Our Ref: PR115191-1
Your Ref: SSD-4972
Date: 26 October 2012

**RE: SUBMISSION TO DEVELOPMENT APPLICATION (REF: SSD-4972)
FOUR POINTS BY SHERATON HOTEL EXPANSION
161 SUSSEX STREET, SYDNEY**

RPS has undertaken a review of the development application documentation in relation to the potential impacts the proposal may have on the current and future tenants of 2 Market Street. In preparing this submission, expert advice was sought in relation to the following:

Figure: Graded height controls of the CBD demonstrating the height of the existing and proposed buildings.
Source: Crone Partners.

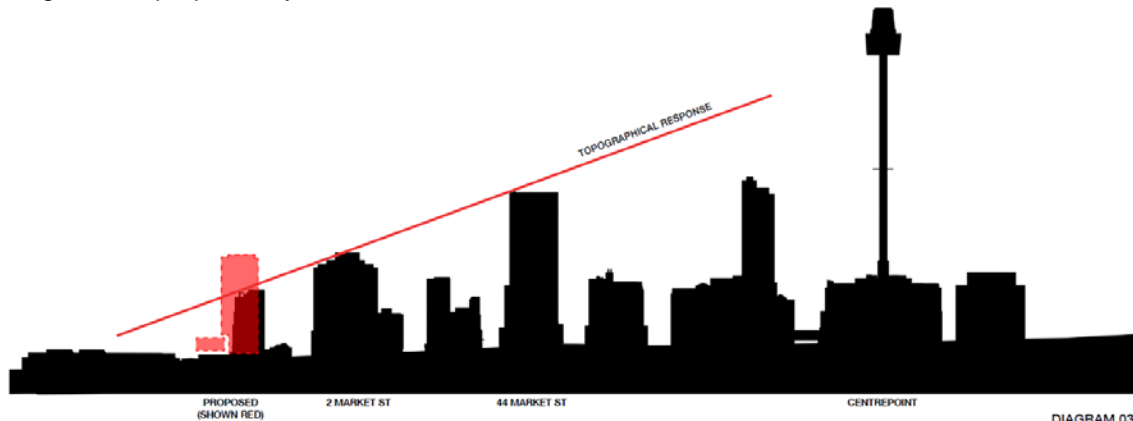
The height of the proposed tower is RL93.6m. The building located at 2 Market Street to the east of Sussex Street is approximately RL95m which will provide a transition in height of 1.4m. This transition in height will prohibit any view sharing from this location along the edge of Central Sydney.

The reduction in height of buildings as they step away from the ridge is demonstrated in the image below prepared by Crone Partners.

The height of the proposed building should reflect the current height of existing buildings located on site. This will result in a bulk and scale consistent with the surrounding development, maintain the height plane of the skyline of the CBD and enable view sharing from the CBD to Darling Harbour.

Figure: East Elevation demonstrating the length contributing to the excessive building mass and scale.
Source: Cox Richardson marked up by Crone Partners.

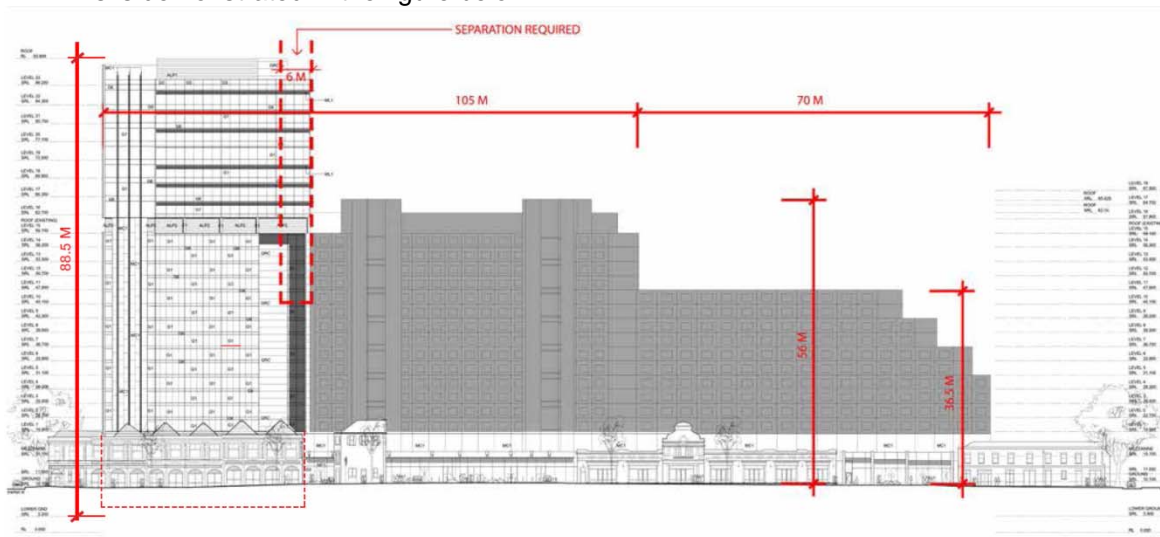
The floor plate combined with the height of the proposed building results in excessive massing. The Typical Hotel Floor Plan (drawing reference: DWG 0206 L04-L10) demonstrates an *excessive uninterrupted hotel building length for the block of 175m*.

This is demonstrated in the figure below.

VIEW A (COX)
Poor Corner Resolution. Heritage Assessment Favours A Curve.

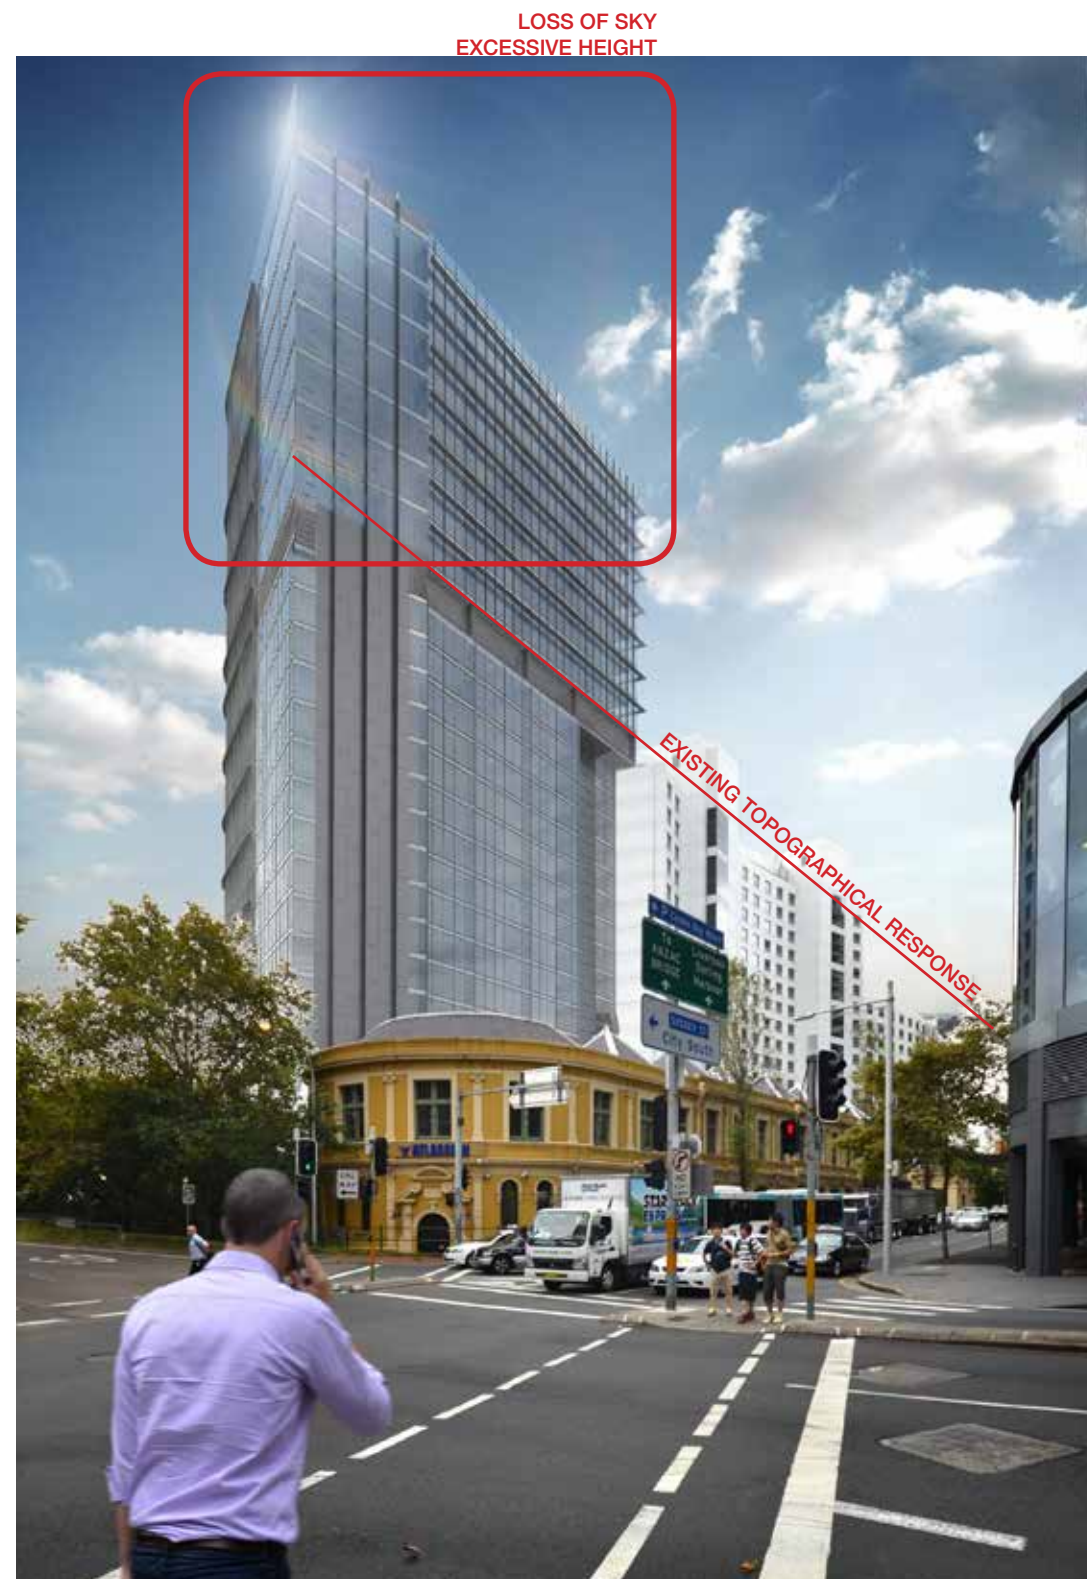
3.2 Address Corner Condition (i) "The orientation of the tower maximises hotel rooms with vistas over Darling Harbour and as a corollary to this, minimises rooms with vistas over Sussex Street".	<p>There is nothing unusual about the tower orientation. The plans actually results in only 7 of 18 rooms directly facing Darling Harbour with the remainder facing either south to Darling Park or east to Sussex Street.</p>

VIEW B (COX)
Distorted And Thus Misleading Viewpoint

DIAGRAM 4
Vista Obstruction

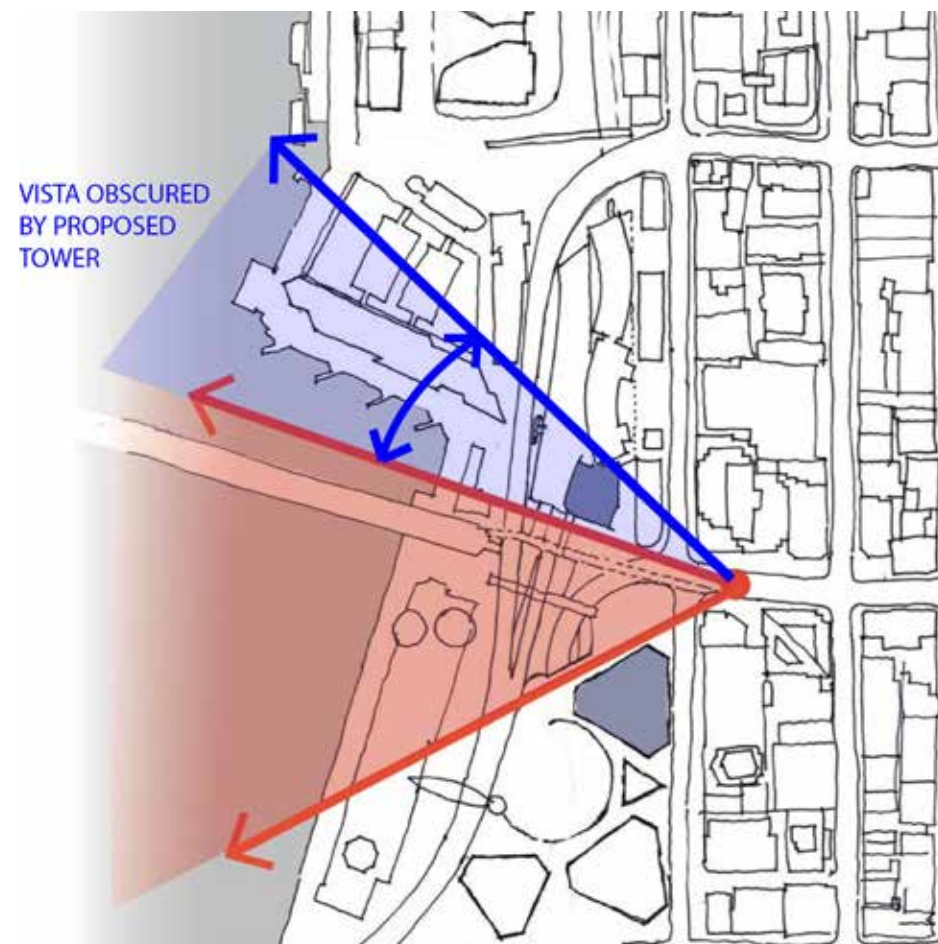
<p>3.4 CBD Gateway</p> <p>“The proposed tower has a significant urban design role to play within the context of Darling Harbour and the Pymont Bridge in enunciating the connection with the entry to the CBD street grid”.</p> <p>“Together with the northern Darling Park Tower the proposed tower frames and identifies Market Street on approach from the west via the Pymont Bridge”.</p>	<p>It is unlikely that the tower will contribute to a Gateway perception. The location of the proposed tower, remote from the true commencement of Market Street, off grid and out of alignment, will more likely be a distraction especially when approaching by car.</p> <p>The Gateway concept, attempting to be achieved by 2 buildings of vastly different scale, spread well apart and not appropriately aligned in relation to the Pymont Bridge axis is spurious.</p> <p>A much stronger argument for the Market Street City gateway can be mounted for the existing 2 Market and 1 Market Street buildings.</p>

DIAGRAM 6 (COX)
East Elevation

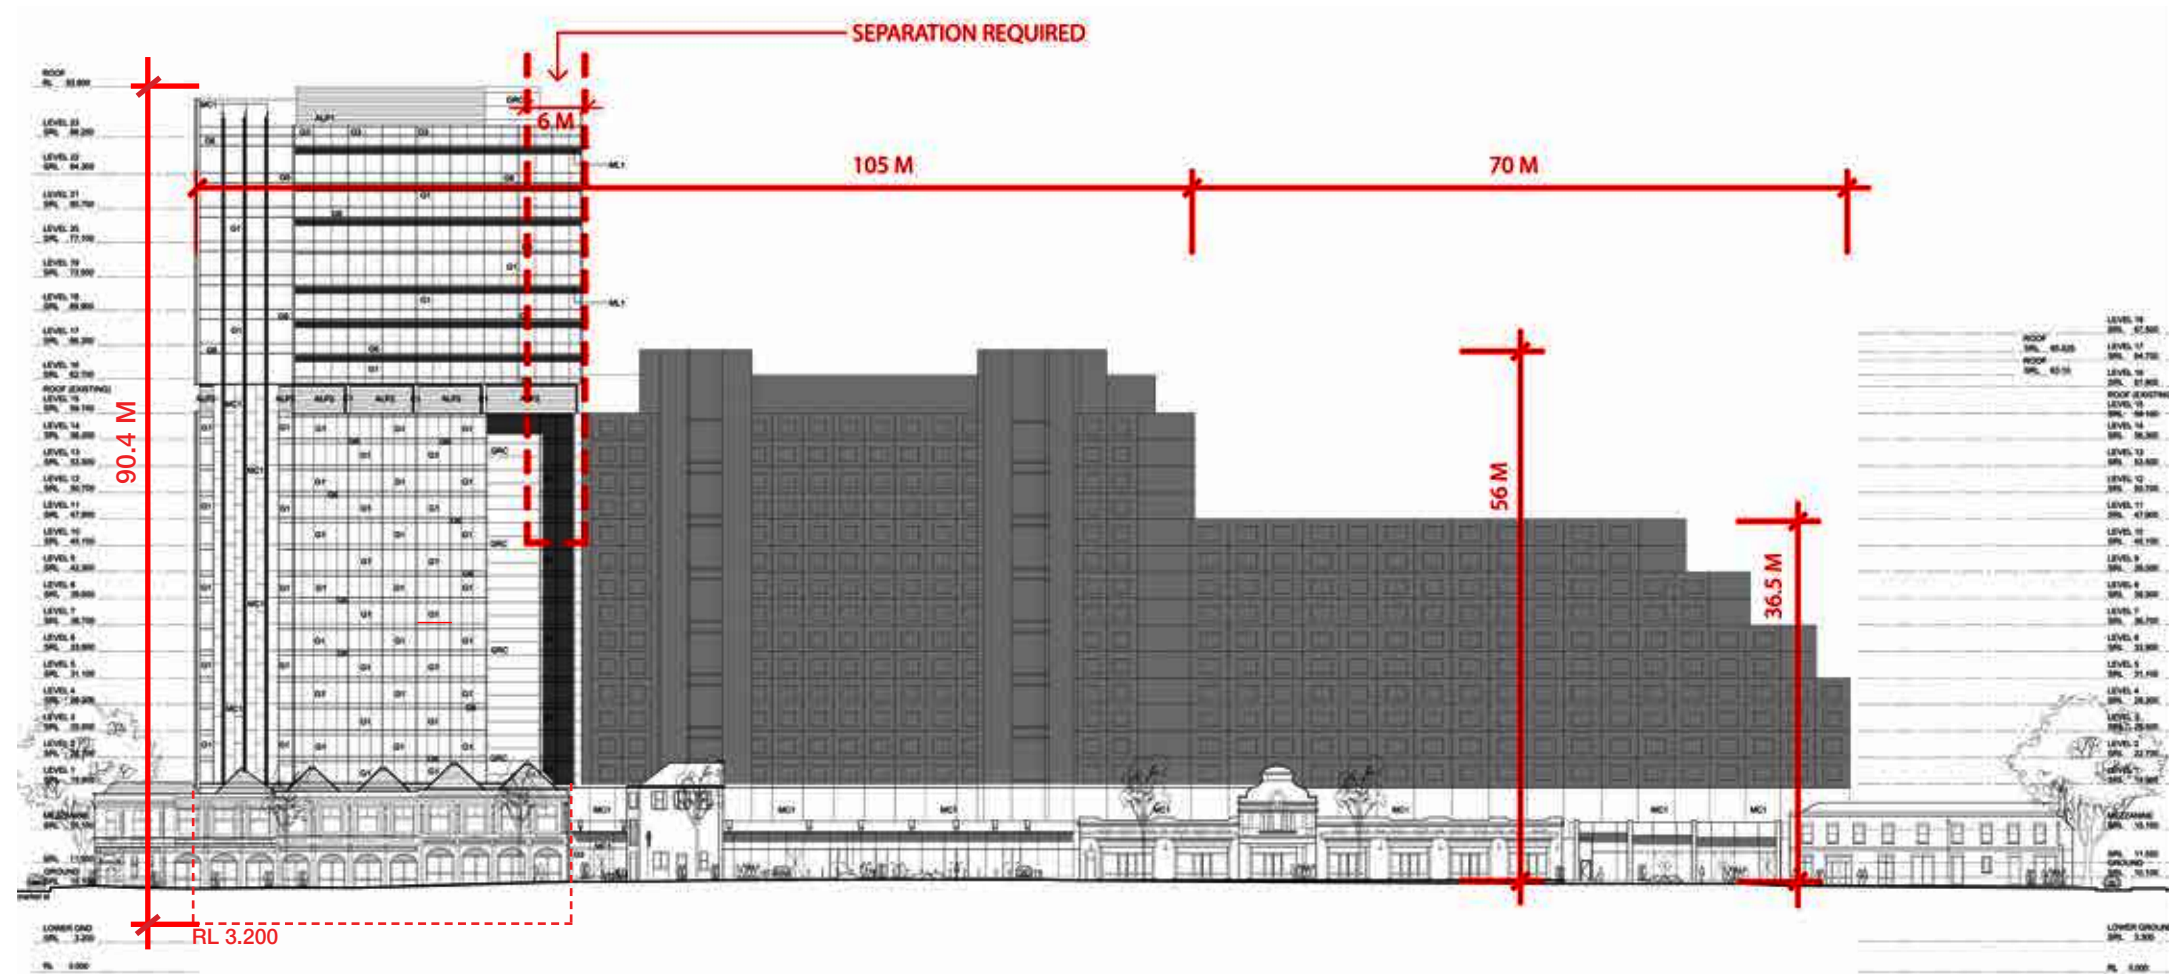
3. East Elevation DWG 0302	Illustrates the considerable uninterrupted length of the building resulting excessive bulk and inadequate tower separation. A portion of the building has a horizontal dimension of 105 metres with a building height of 56 metres or more. Building separation is essential to break this down. Refer Diagram 6.

VIEW Q (JBA)
Distorted Aerial View Is Misleading

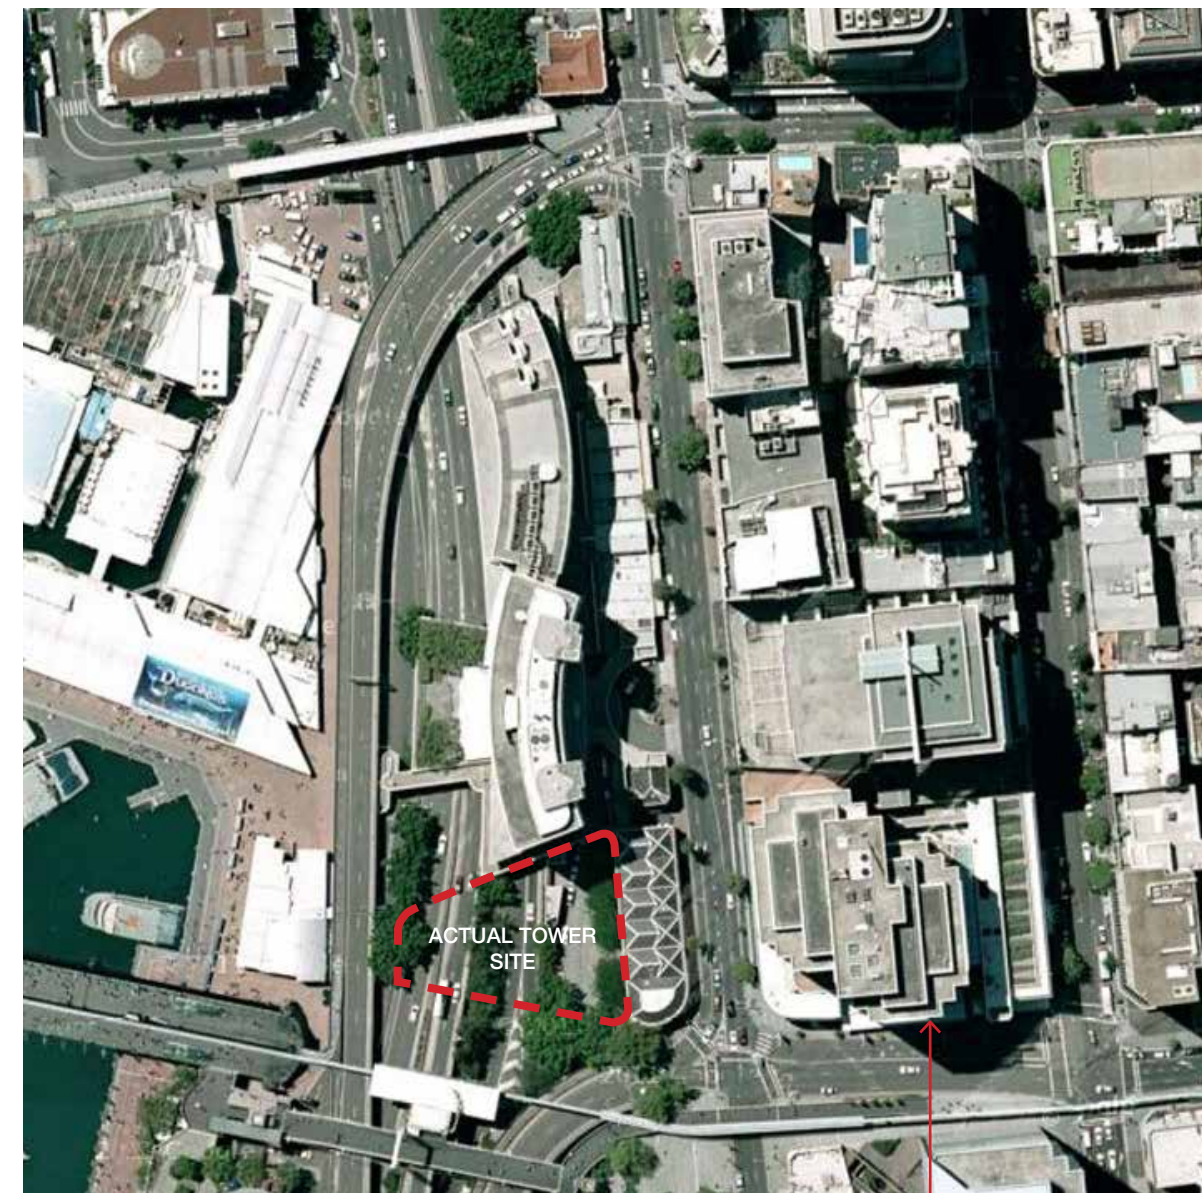
APPARENT LOCATION OF
2 MARKET ST BEHIND
PROPOSED TOWER

2.2, Fig 2 Site Plan	
The aerial view used by JBA is unfortunate as it (possibly inadvertently) is highly deceptive and misleading with regard to some critical issues.	<p>On examination it can be seen that the photo is not taken from directly overhead but from north of the site. The distortion means that buildings and spaces are not properly represented.</p> <p>For instance, the Hotel currently terminates at the north end of the Corn Exchange whereas in the photo it appears that they overlap. Refer View Q. As a consequence the proposed tower site looks quite small whereas it is in fact double the land area visible. Refer View R.</p> <p>Further because the roof to 2 Market Street is not over its base it appears as if it might look past the proposed tower to Darling Harbour. The fact is the new tower is squarely in front of 2 Market and blocks all of its direct views.</p>
